PUBLIC WORKS/HYDROLOGY

AREAS OF MODIFICATION BETWEEN APPROVED DRAINAGE GRADING PLAN AND ACTUAL AS-BUILT

JEFFERSON COMMONS LOTS 4 and 5
DRAINAGE / GRADING PLAN

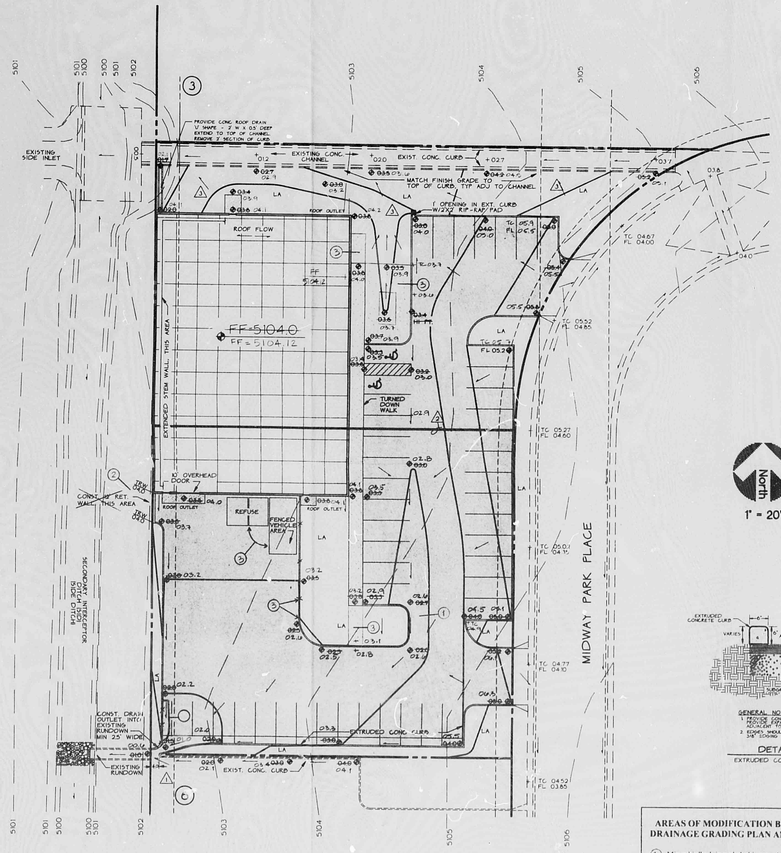
1. REMOVE EXISTING CURB AS INDICATED TO ALLOW LOT 6 FLOWS TO ENTER EXISTING RUNDOWN UNHINDERED (SAME OWNER)
2. PROPERTY LINE ADDED.
3. OWNER TO PROVIDE SEDIMENT CONTROL THIS AREA.

1. Minor birdbath in asphalt this area. Acceptable.
2. Retaining wall at southwest corner of building was not constructed. Acceptable due to existing grades this area.
3. Site plan feature not shown on original plan. Acceptable. Does not affect drainage.

JEFFERSON COMMONS LOTS 4 and 5
DRAINAGE / GRADING PLAN

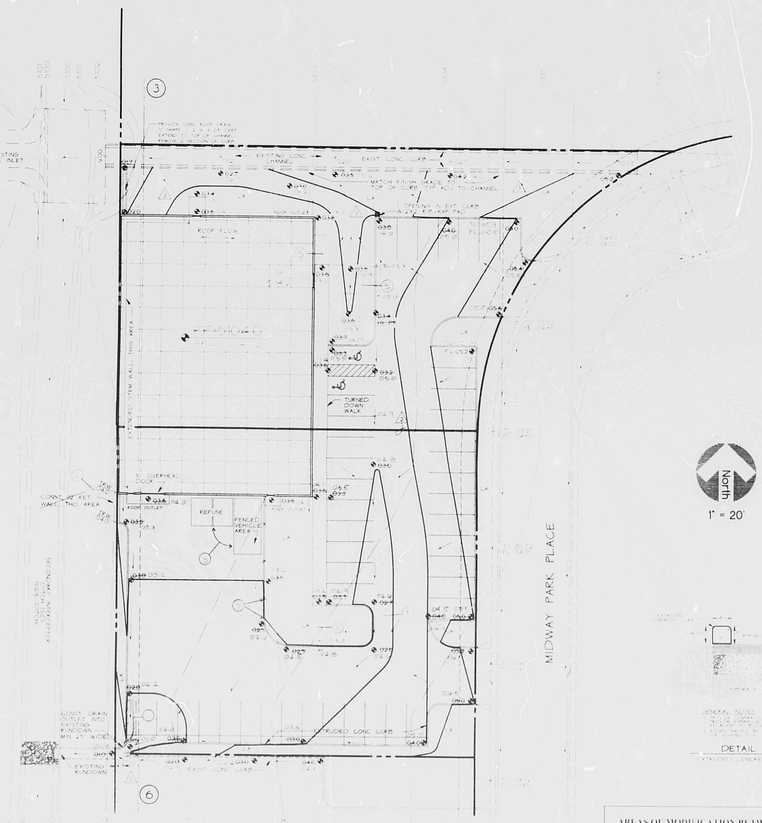
1. REMOVE EXISTING CURB AS INDICATED TO ALLOW SURFACE FLOW TO ENTER EXISTING FUNCTIONAL UNDERGROUND CHANNEL SYSTEM
2. PROPERTY LINE ADJUSTED
3. [illegible]

1. Minor hardscape in asphalt this area. Acceptable.
2. Retaining wall at rear/east corner of building was not constructed. Acceptable due to drainage/grades this area.
3. Site plan feature not shown on original plan. Acceptable. Does not affect drainage.
